HISTORIC DISTRICT COMMISSION

**CONWAY
HISTORIC DISTRICT COMMISSION
MEETING**

AUGUST 24, 2015 • 6:00PM • CITY HALL • 1201 OAK STREET

1A First Church of the Nazarene Metal Van Cover - 1516 Scott Street

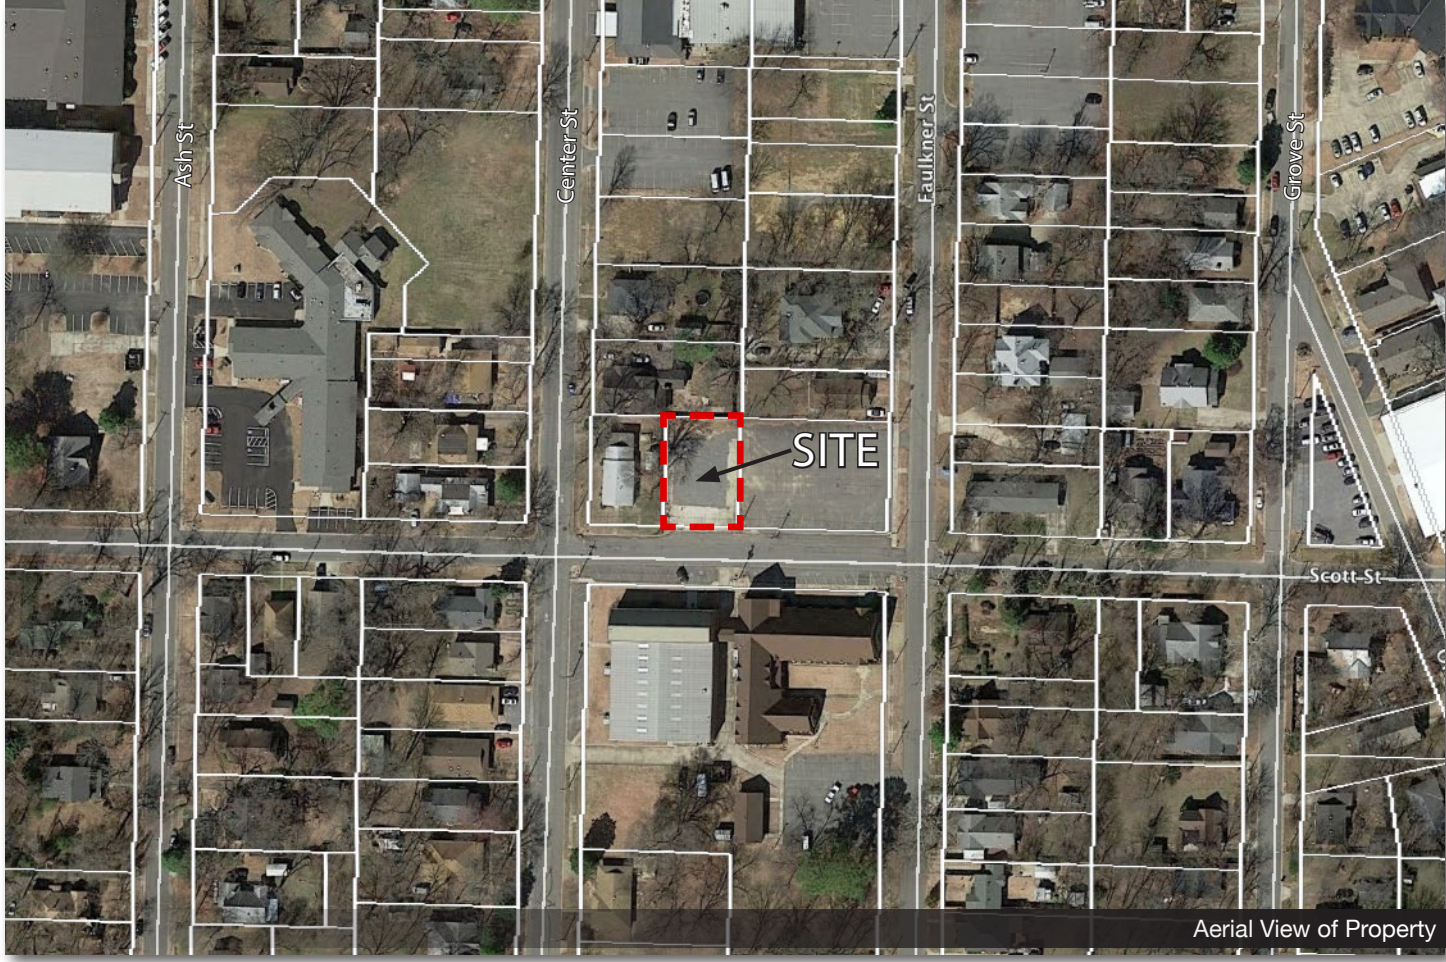
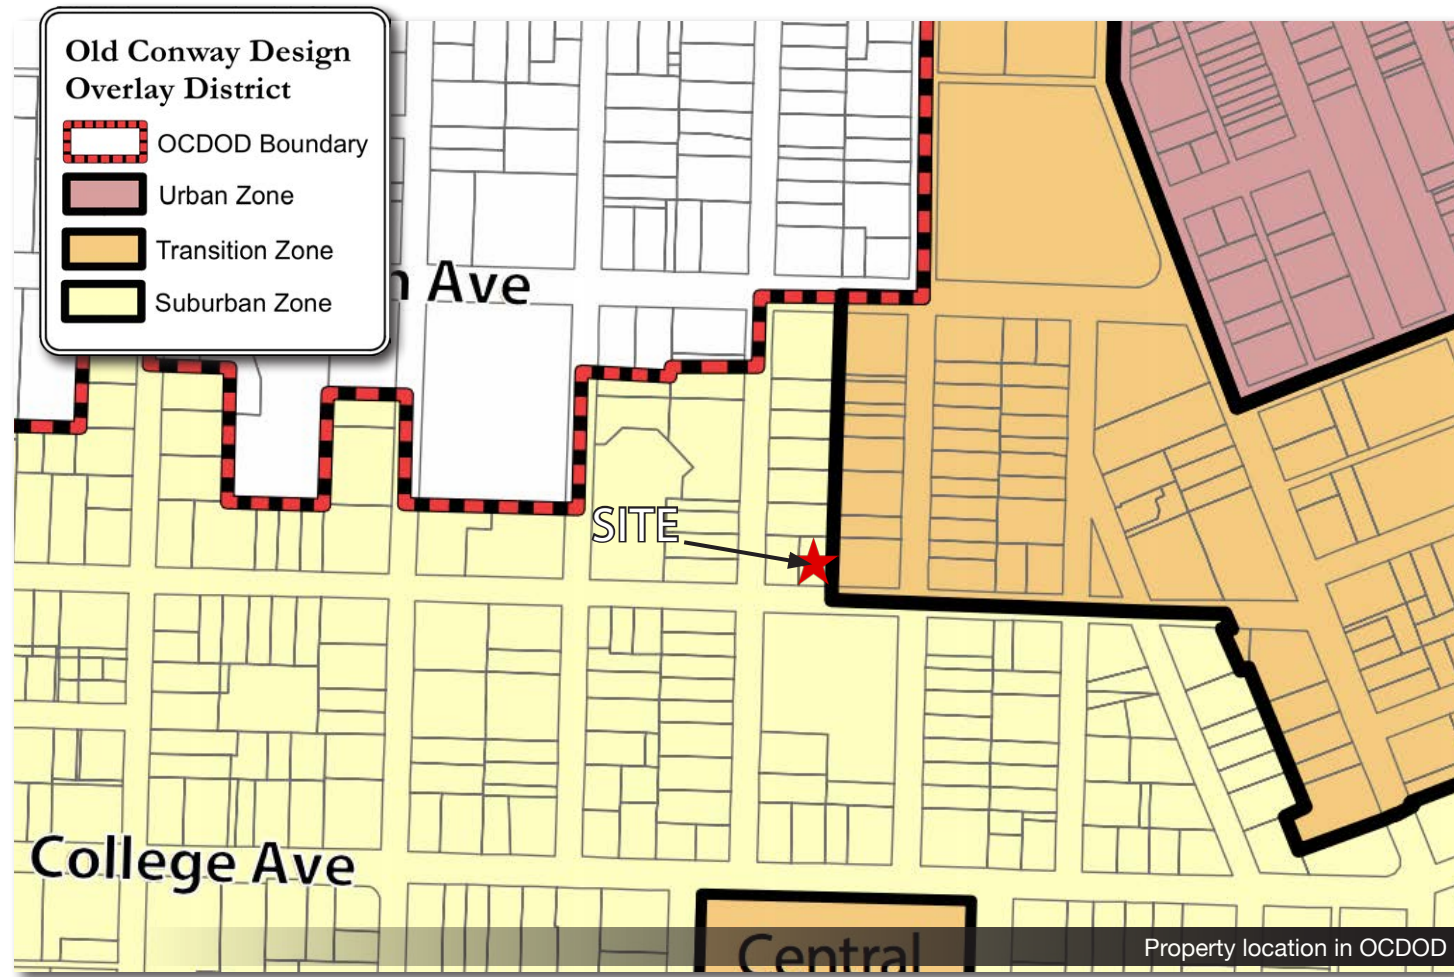
General Description of Property and Proposed Development. The First Church of the Nazarene would like to place a ~540 square foot metal cover over their Church van to protect it from the weather. Because the metal cover is over 160 square feet, it requires review by the Historic District Commission. The proposed location is the northwest corner of the empty lot formerly occupied by a large “barn like” duplex. The metal cover could be seen as a temporary structure.

Setbacks. The proposed cover would be set back 2 feet from the north property line and 0 feet from the west property line.

The proposed cover is a utilitarian structure that is basically a metal roof. The structure is not traditional in nature or constructed of traditional materials. However, as a temporary utilitarian structure it could be considered acceptable.

- The cover shall be located and constructed as shown on submitted plans.
- The north setback shall be around 2 feet from the north property line. West side setback shall be allowed at 0 feet.

**ROBINSON HISTORIC DISTRICT
CERTIFICATE OF APPROPRIATENESS REVIEW**

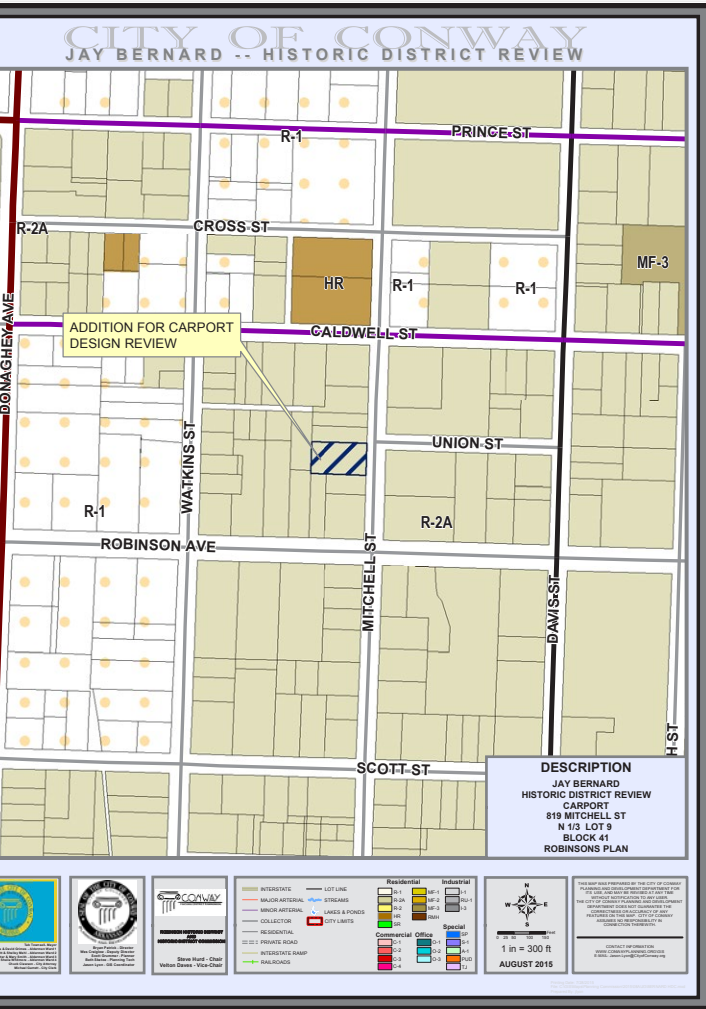
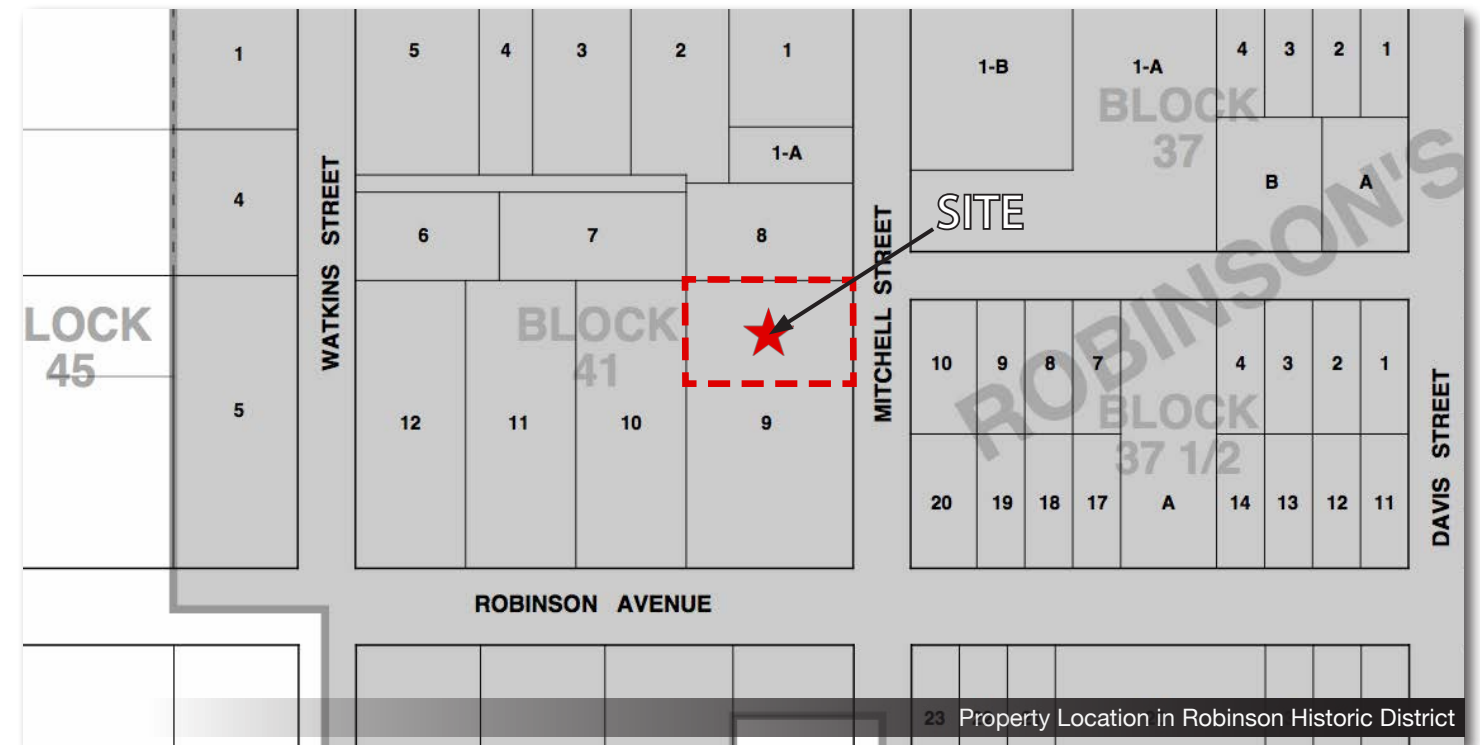
General Description of Property and Proposed Demolition. The Bernards would like to demolish the duplex. The home no longer has the original windows and is covered in vinyl siding. Pictures made of the house for the 1998 Robinson District architectural survey show that there was no vinyl siding and original windows were on the home in 1998. The applicant has supplied an appraisal of the property. The appraisal does not give a value for the structure, only the land value. Also submitted were a renovation proposal and demolition estimate.

The 1998 Robinson District Survey listed the residence as a contributing structure. However, since that time the home was covered with vinyl siding and original windows have been replaced. The survey of the residence is enclosed on pages 10-13. It would appear there is reason for the HDC to consider demolition based on criteria Number 2 - Economic Hardship, Number 3 - Structural Instability, and Number 4 - Loss of architectural integrity. (Possibly was not contributing as noted in the 1998 survey.)
